Docket Number:	07-AFC-06C
Project Title:	Carlsbad Energy Center - Compliance
TN #:	203363
Document Title:	Project Owner's Responses to Data Requests Set 4 (Nos. 86-92)
Description:	N/A
Filer:	Dee Hutchinson
Organization:	Locke Lord LLP
Submitter Role:	Applicant Representative
Submission Date:	11/21/2014 2:29:40 PM
Docketed Date:	11/21/2014

Re: Carlsbad Energy Center Project Petition to Amend (07-AFC-06C)
Responses to Data Requests Set 4 (Nos. 86-92)

Data Response Set 4 (Response to Data Requests 86 to 92)

FIGURE DR 86-1
Water Balance Diagram
Maximum Use Case
Carlsbad Energy Center Project
Carlsbad, California (07-AFC-06C)
Petition to Amend

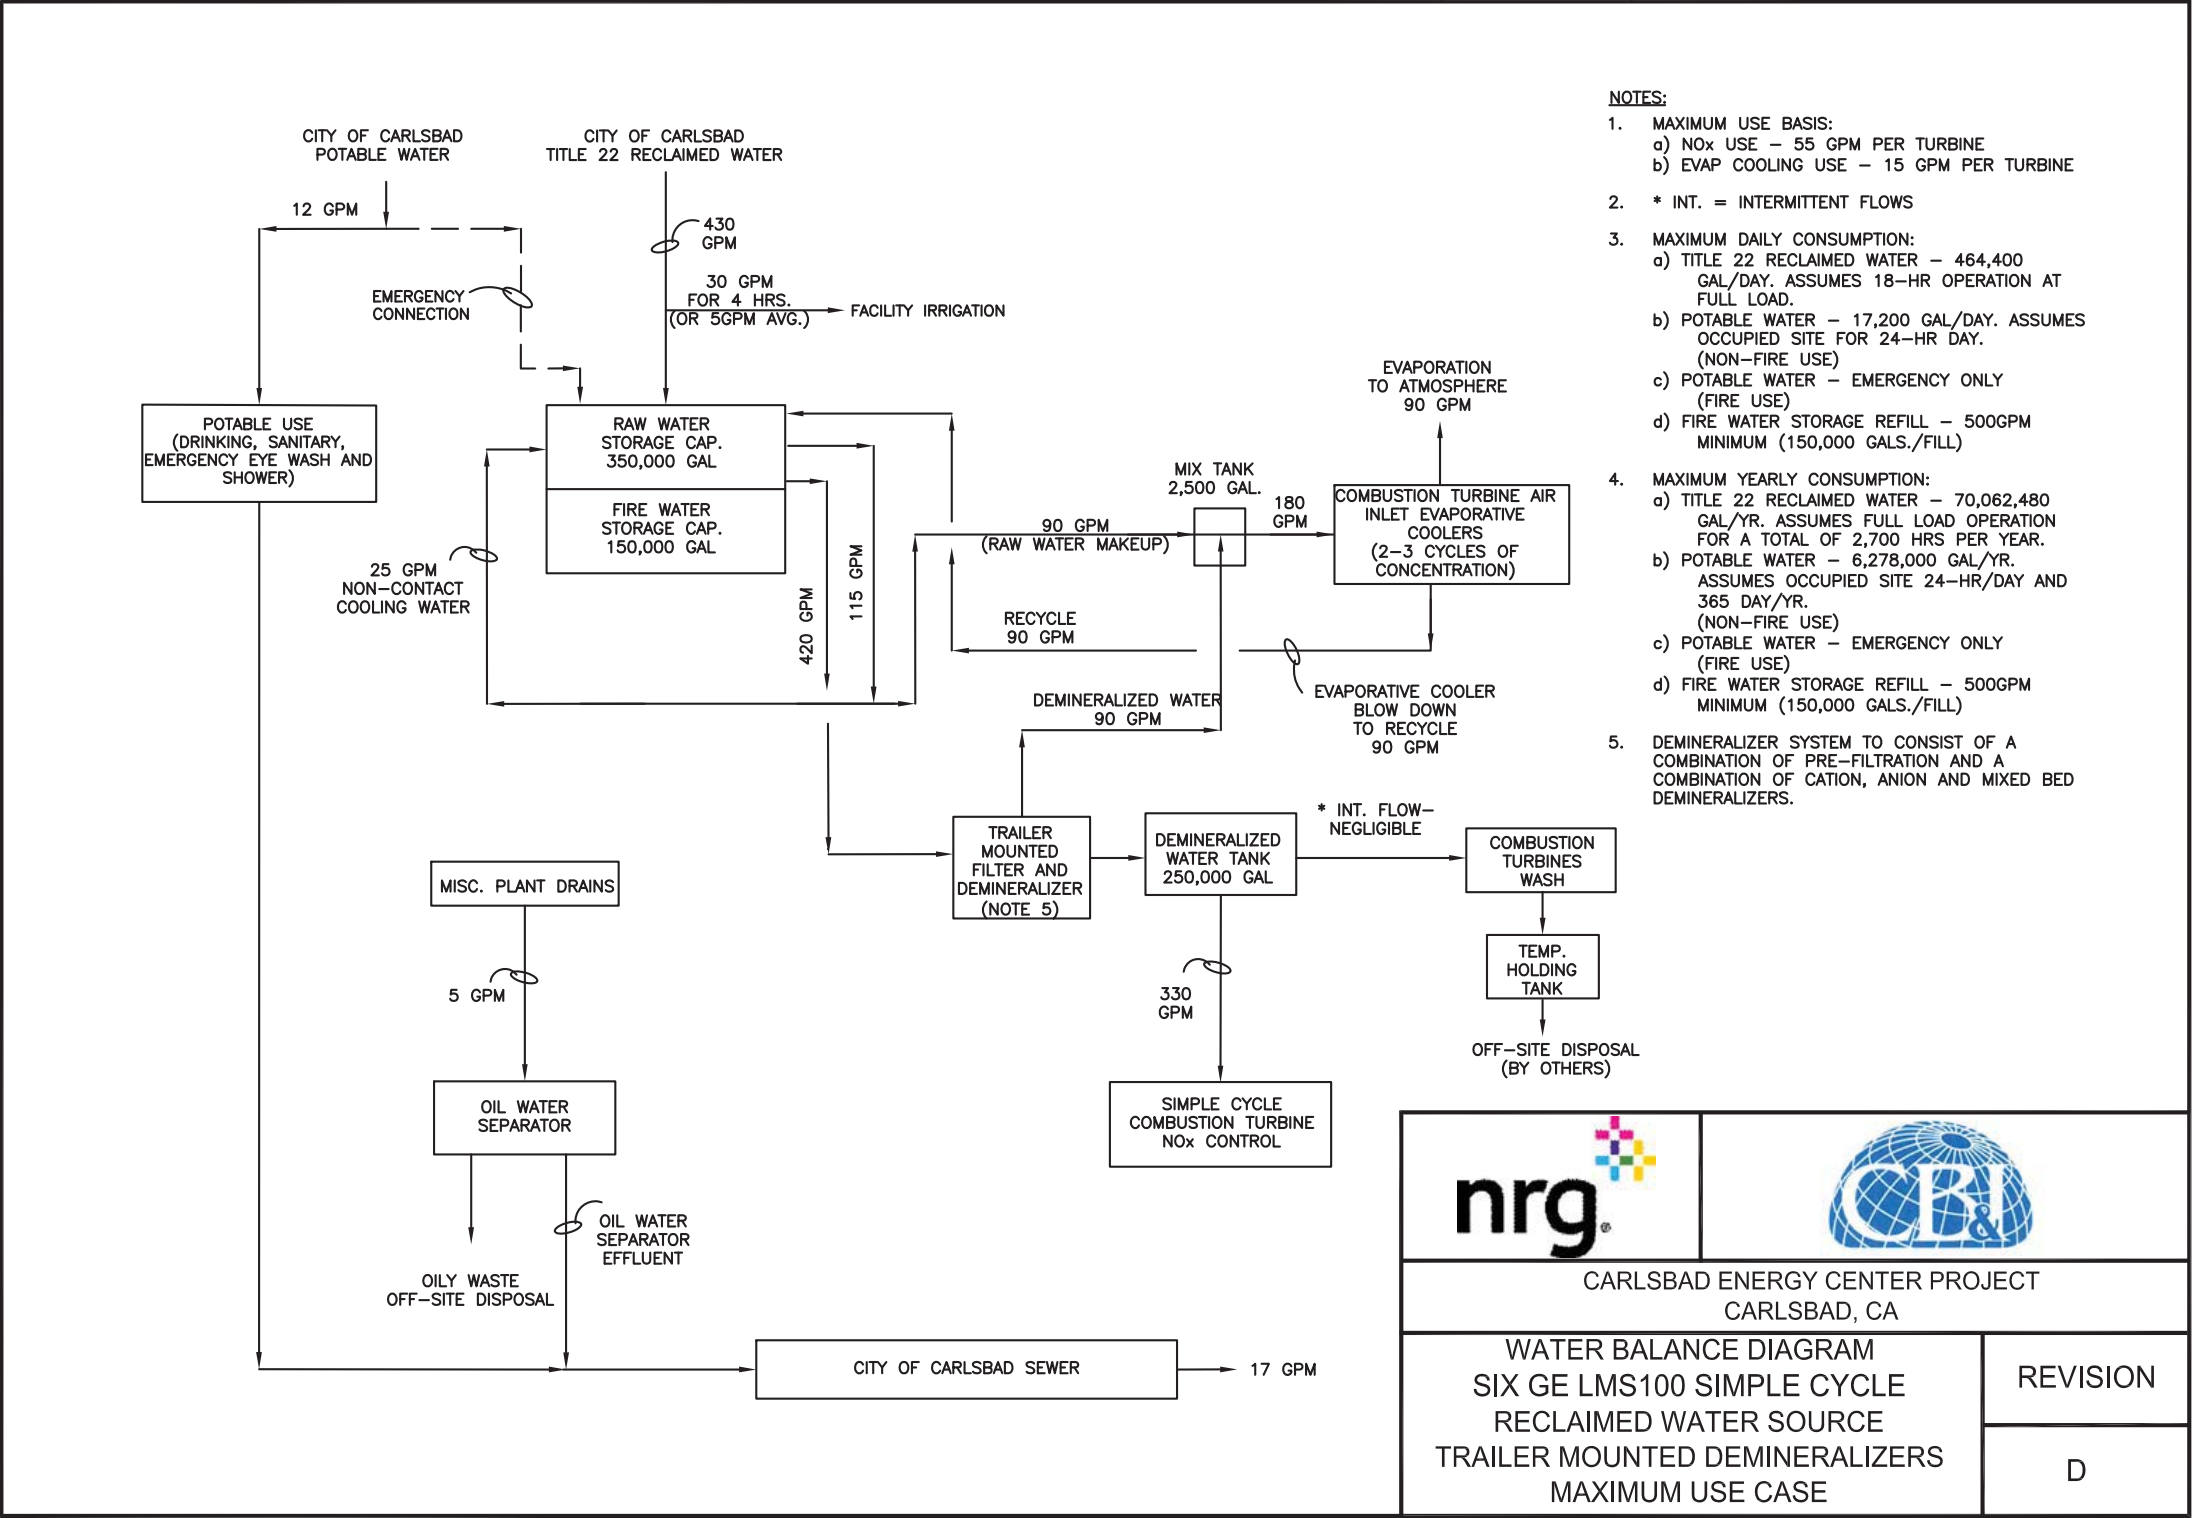
86. Please describe alternative wastewater discharge options currently under consideration for the amended CECP, including flow diagrams showing how the discharges would be routed and/or treated.

The reclaimed water with trailer-mounted demineralizers water balance diagrams (Figures DR86-1and DR86-2) show revised water balances and process flow for both a daily maximum and yearly average use. Figure 2.1-1R shows the location of water treatment and handling equipment on site. Several other figures are provided in revised form with this data response set to ensure consistency in the project description, Figure 2.0-1R Site plot plan and Figure 3.1-1R Transmission Lines.

As explained above, the Project Owner has identified and proposed increased use of the trailer mounted demineralizer units to maximize water reuse and reduce waste water discharge to minimal amounts that are easily accommodated. These changes resolve any perceived compliance issues with Encina Wastewater Authority constituent limits. As discussed in the General Response to DRs 86 – 90 above, the addition of the trailer mounted demineralizers system and the corresponding elimination from further Project consideration of the ocean water purification system will not result in significant adverse environmental effects. In fact, with the reduced wastewater discharge and the removal of the ocean water purification system from further Project consideration will result in environmental improvements to the Project.

FIGURE DR28-4R1
One Line Diagram
Carlsbad Energy Center Project
Carlsbad, California (07-AFC-06C)
Petition to Amend

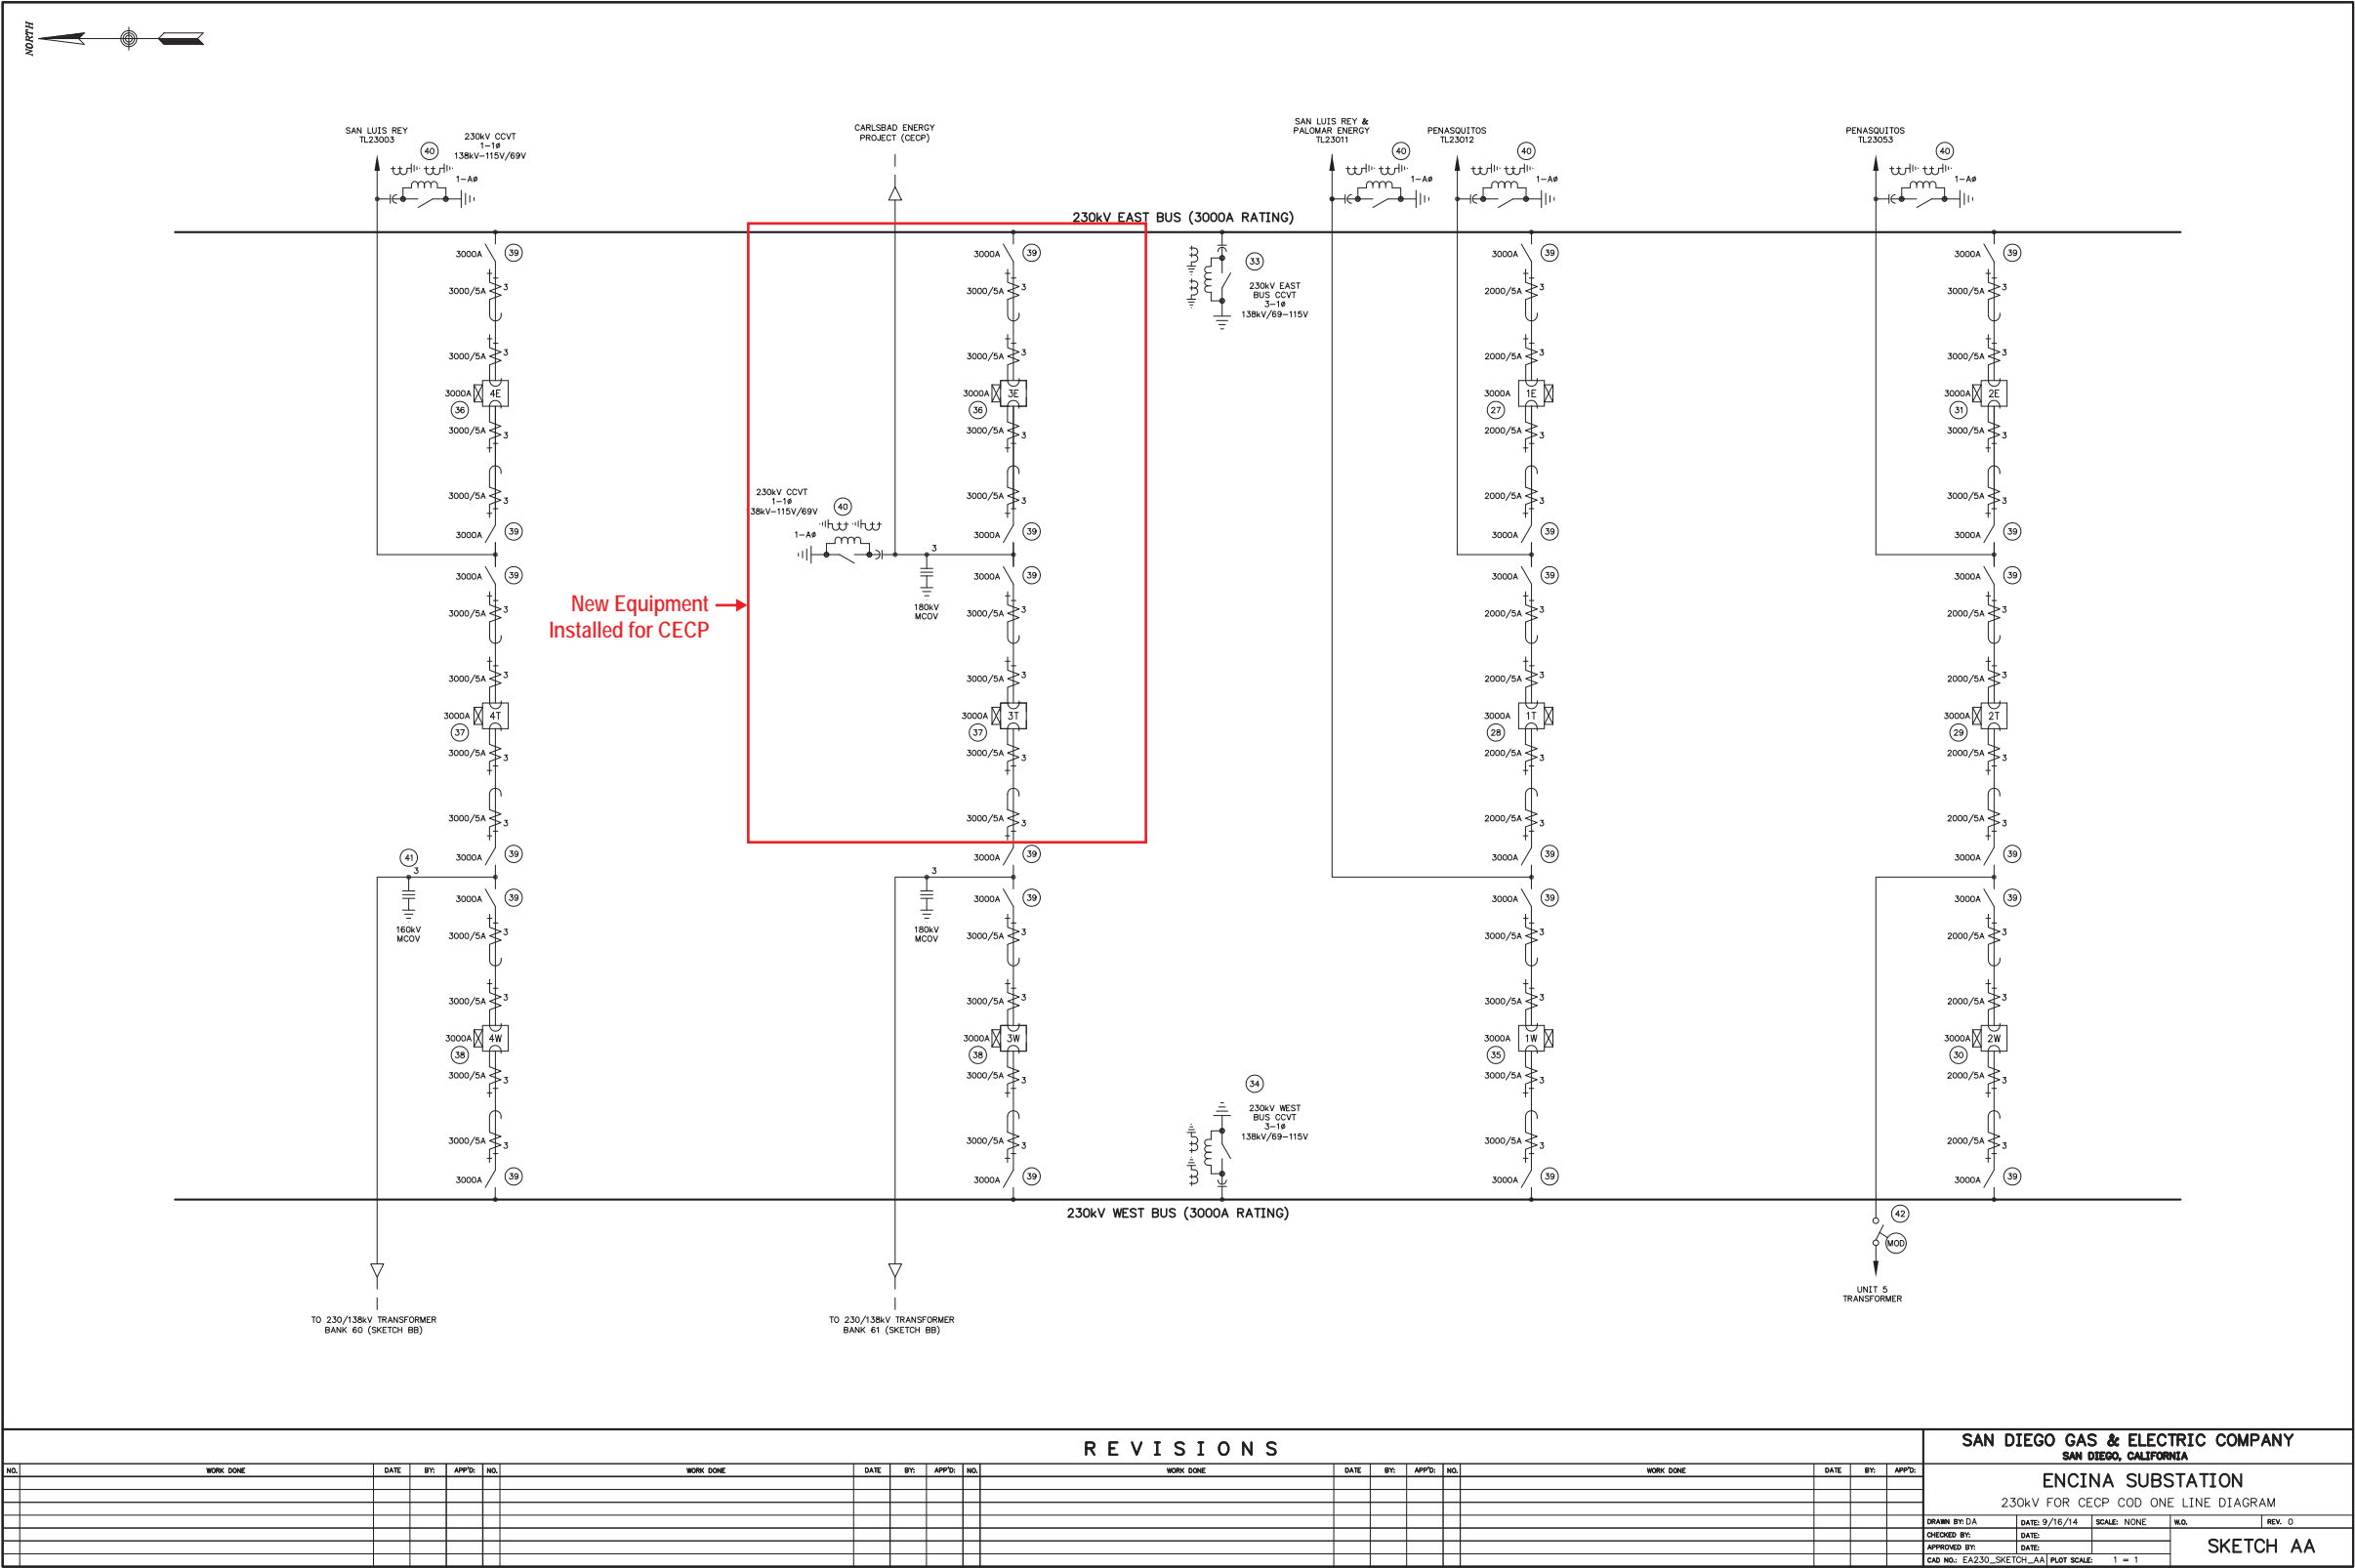
92 .Describe the proposed actions/modifications that would be required by SDG&E to make space for a switching bay position for terminating the CECP 230 kV gen tie line, and please resubmit Figure DR28-4 (the post-project one line diagram of SDG&E 230 kV switchyard showing the new switching bay no. with installations such as additional breaker(s) with associated disconnect switches etc. with their ratings), and depict the intended actions/modifications necessary for the switchyard to accommodate the incoming amended CECP 230 kV gen tie line.

SDG&E will be installing two 230kV breakers (3E, 3T) and two 230kV switches and associated bus work to accommodate the CECP interconnection within the switchyard. There is no switching of any bay positions needed within the SDG&E 230kV switchyard to accommodate the new CECP 230kV line.

Figure 28-4R is provided herein with the section highlighted as to the location that CECP will be interconnected within SDG&E 230kV switchyard.
